SUNDRY NOTICES AND REPORTS ON WELLS
Do not use this form for proposals to drill or to re-enter an abandoned well. Use Form 3160-3 (APD) for such proposals.

8. Well Name and No.
ARENA ROJA FED UNIT 16H

DEVON ENERGY PRODUCTION COMPANY LP

PROPOSED WELLBORE

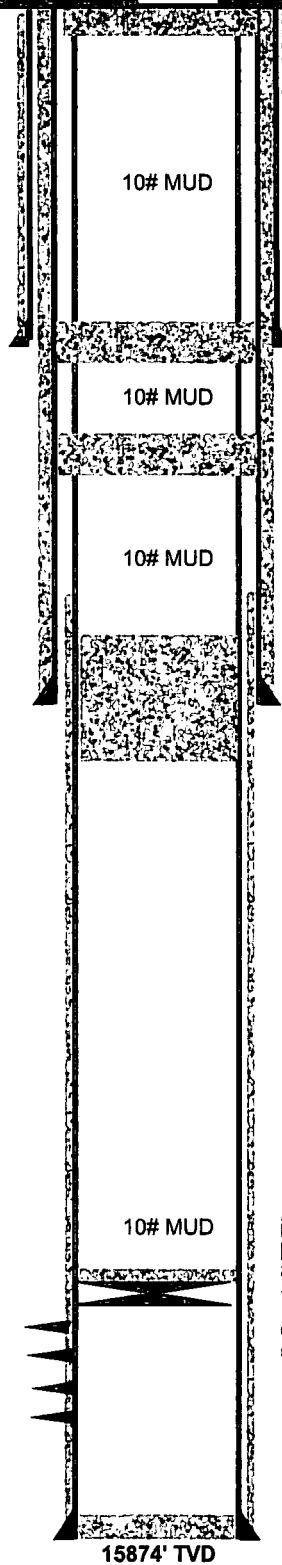
190' min. (8910)
Add plug (B/salt) 4930-4780. WOC Tag.
(T/salt) Perf @ 1585-502cm to 1485.
WOC Tag.

Below ground level dry hole marker required
